November 25, 2002

**NOTICE OF VIOLATION; STORM WATER PERMITTING REQUIREMENTS; GOLDIE
 LANE PROPERTY; SANTA MARGARITA; SAN LUIS OBISPO COUNTY; WDID# 3 40S319357**

Photo 1 – No erosion or sediment control.

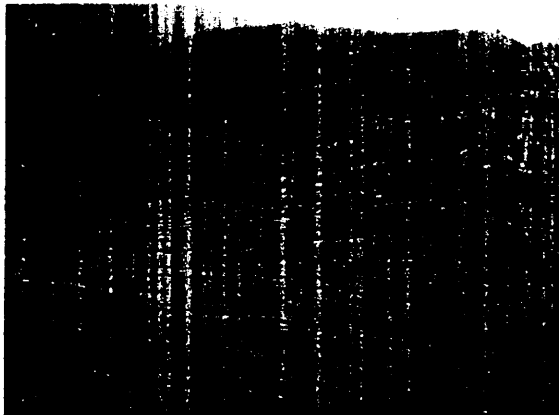
The Storm Water Pollution Prevention Plan (SWPPP) for your site outlines erosion and sediment controls. We were assured by Dave Williams of your staff and by staff of your consultant, EDA Design Professionals, that erosion and sediment control would be in place prior to the first rains of the season as outlined in the SWPPP. However, no erosion control and no sediment control were in place after the first rains (Photos 1, 2). Failure to implement erosion and sediment control measures is a violation of Part C.2 of the Permit.

Photo 3 - Road eroding away, no erosion or sediment control.

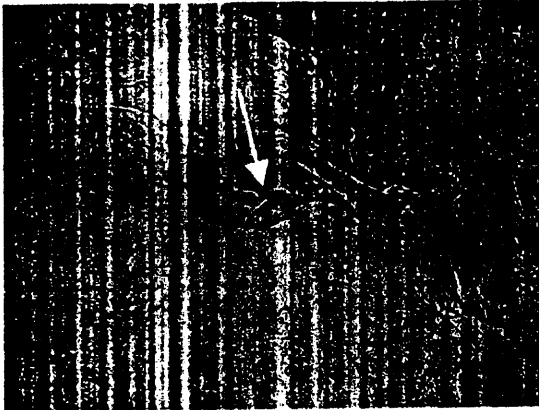
The access road that transverses the property is also eroding in several locations. There were no erosion or sediment controls on the roadway. As a result the road is washing away at several locations (Photos 3, 4). The road threatens to wash into the unnamed tributary to Huerhuero Creek. Steps should be taken to stabilize the road to prevent further erosion.
